Minutes from Sector 1 Relocation Meeting, May 22nd 9:15 LCR

Sector 1 Instrument Relocation for LEReC

May 22, 2015

ARTUS Kickers

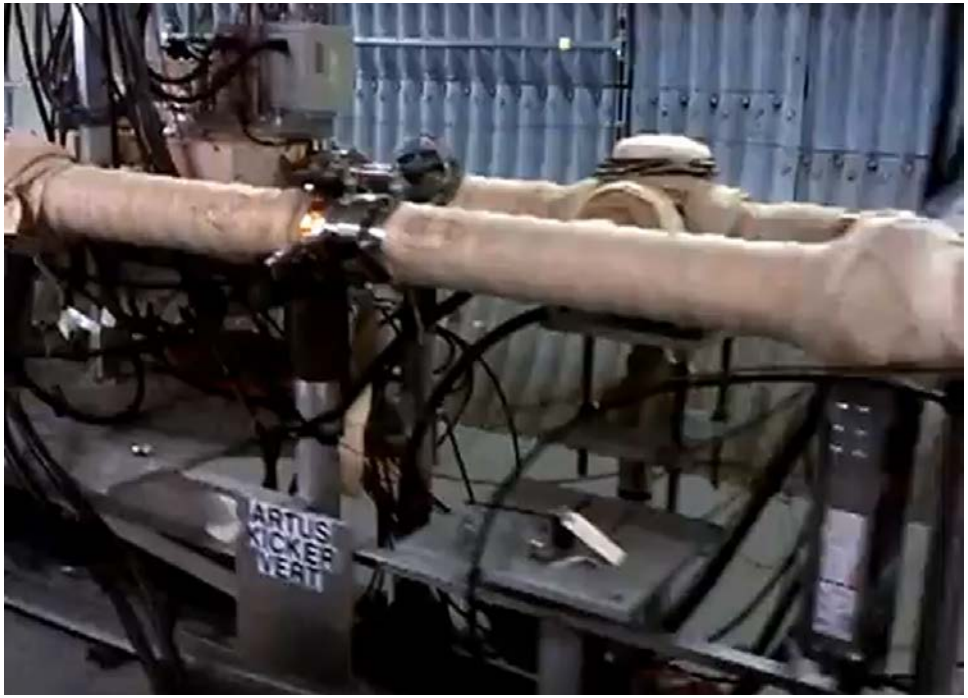
- Rob M is following up with Angelika regarding beta function considerations of the new proposed locations of the ARTUS kickers adjacent to the existing ones in sector 2.

Ionization Profile Monitors

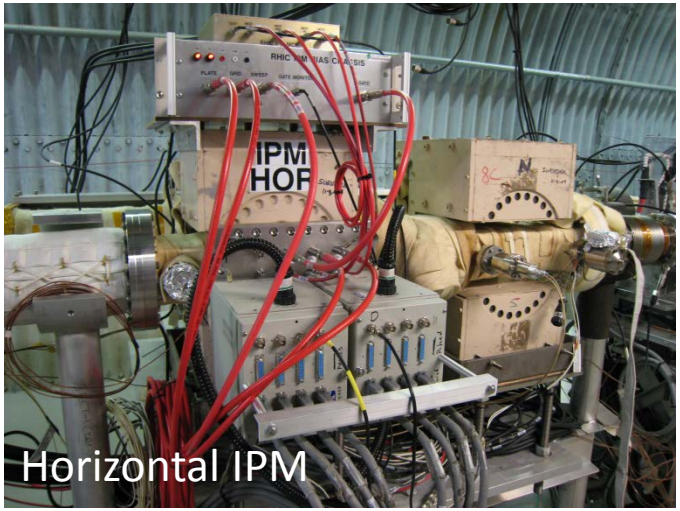
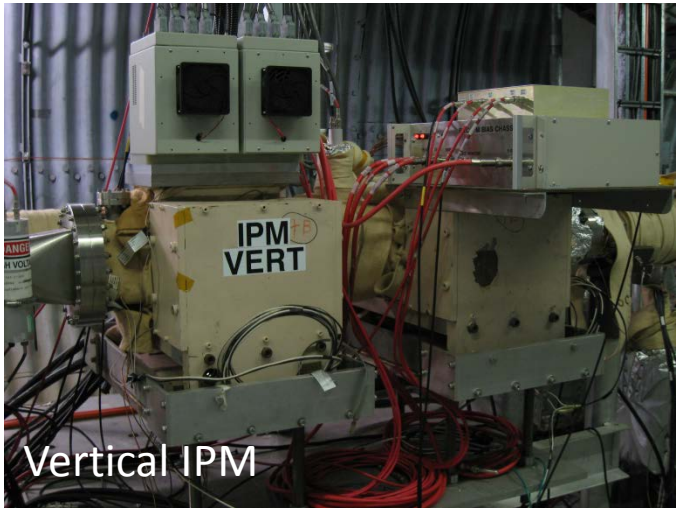
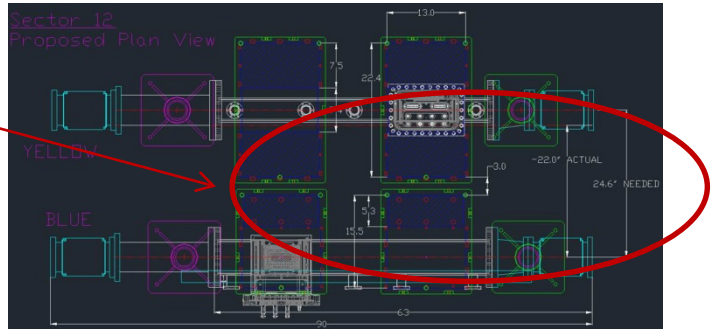
- The preference is for the IPMs to be installed as close to Q3 as possible in sector 12. Since they need to be offset because the beam pipes are close together, the horizontal should be closer to Q3. Jesse will layout new IPM locations (plan view) with longitudinal offset and separate stands for review.

A common stand for both IPMs in sector 12 was considered until Jesse found a conflict. Present plan is for separate stands with the IPMs offset enough for clearance.

Triple Pick-up Assembly

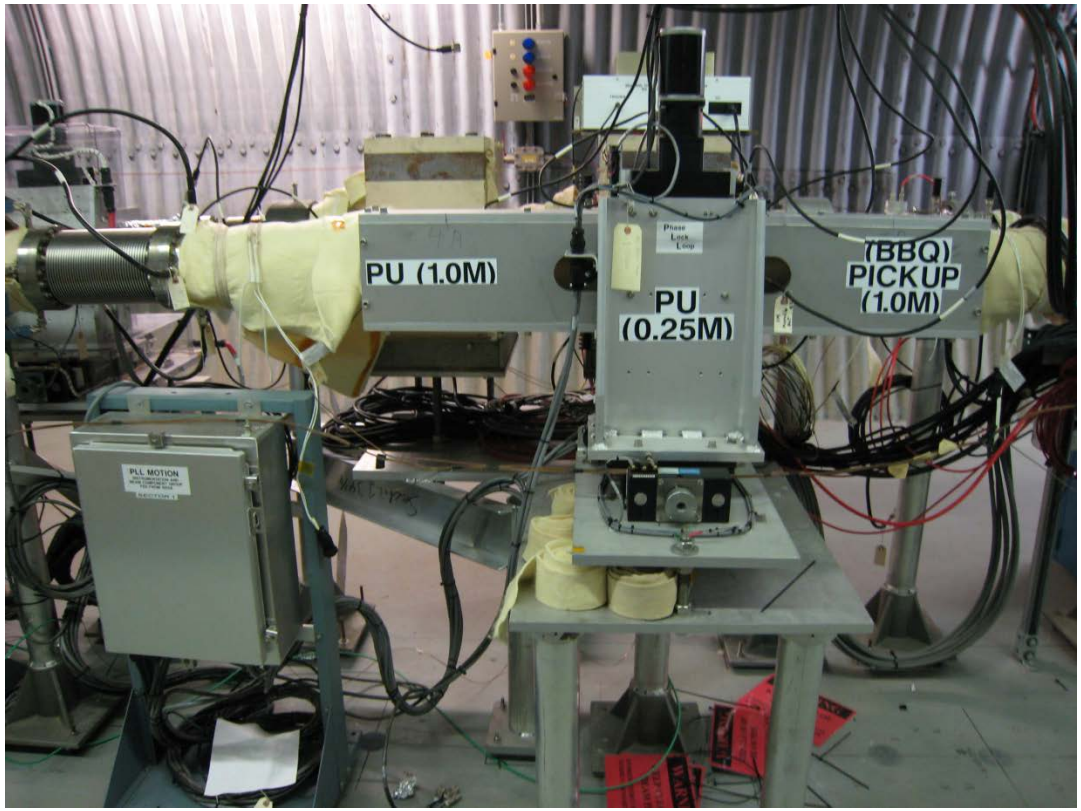
- K Mernick recommends that we don't need the moveable X-Y capability on the triple purpose pick-up, this can simplify the relocation effort and beam line assembly.

- K Mernick requests that the Quad PU (0.25m) from YO1 (40m) be relocated (instead of removed), a suggestion is closer to Q4 in YO1, get confirmation from Kevin on new location.

BBQ Kicker (1m strip line)

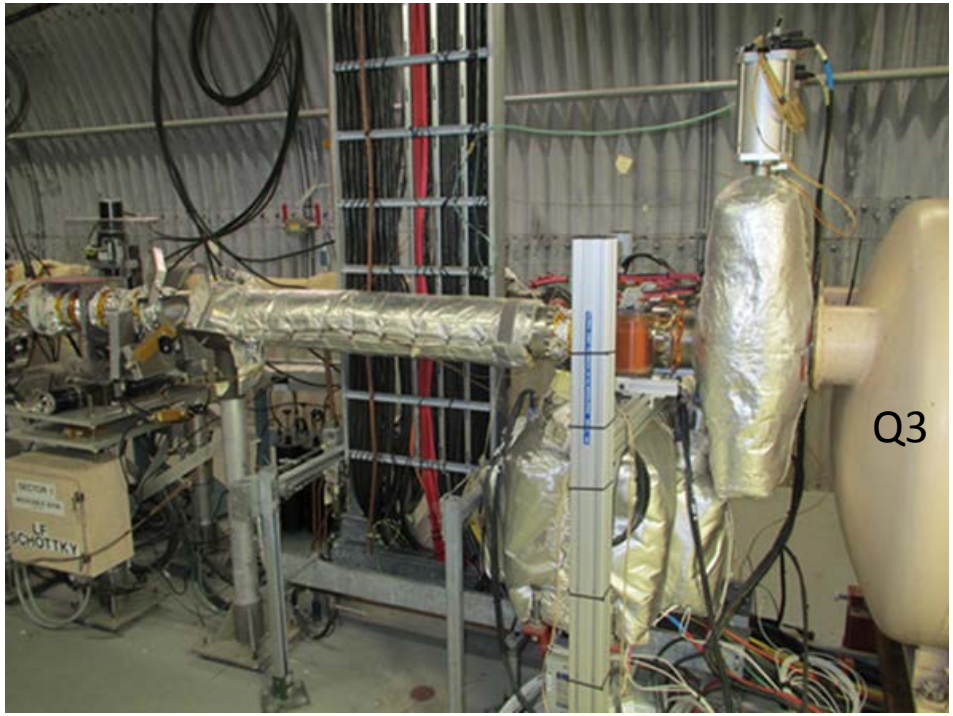
- K Mernick suggest moving the BBQ kicker and triple purpose pick-up assemblies to sector 2, yellow (it appears that there is room). This allows shorter cable lengths, moving towards YO1 Q4 would have meant (undesirable) longer cables than the existing.
